ADMINISTRATIVE AMENDMENT

PROJECT NUMBER: PR-2020-003455

VIEW HOUSE APARTMENTS

REC/LEASING
PRELIMINARY ELEVATIONS

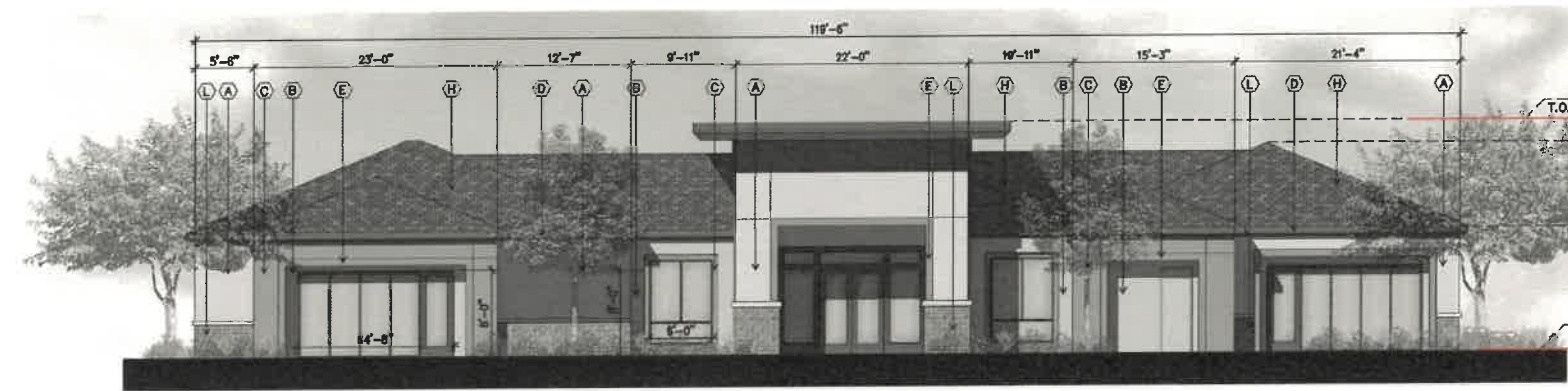
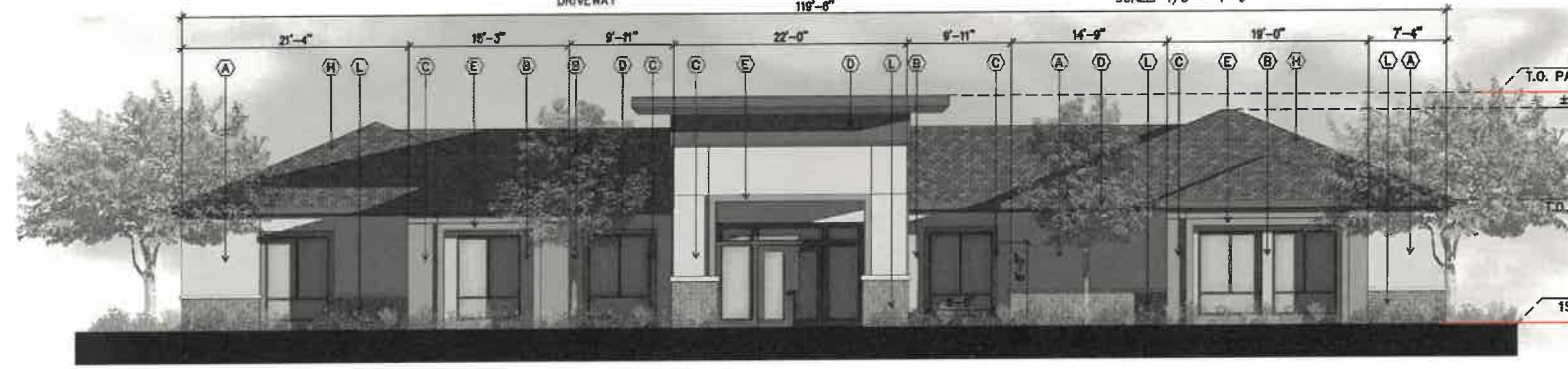
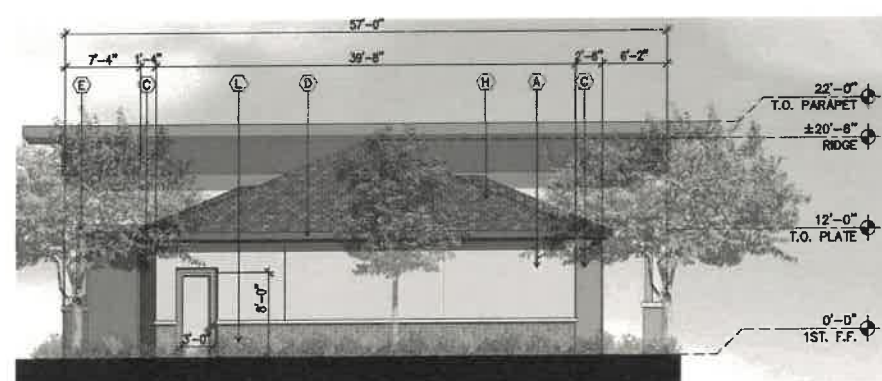
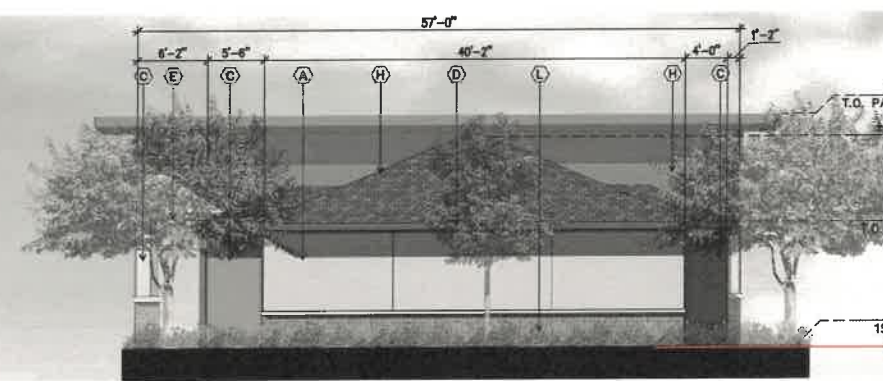
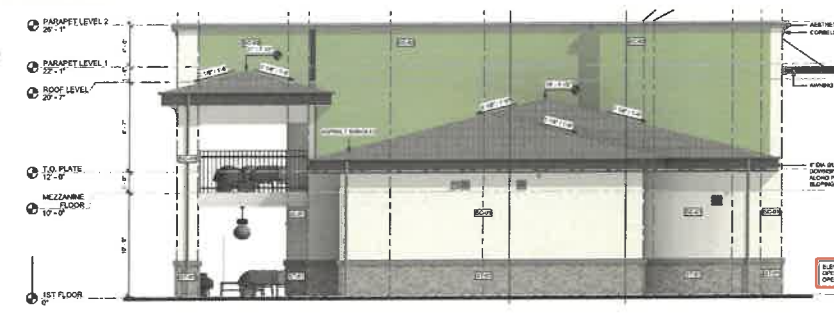
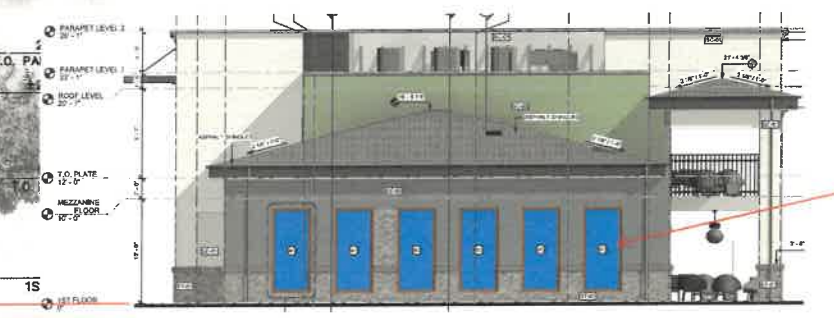
increased height of this area to allow mezzanine access.

increased parapet heights to obscure mechanical equipment

Added balcony area overlooking pool

Windowed areas added to fitness room
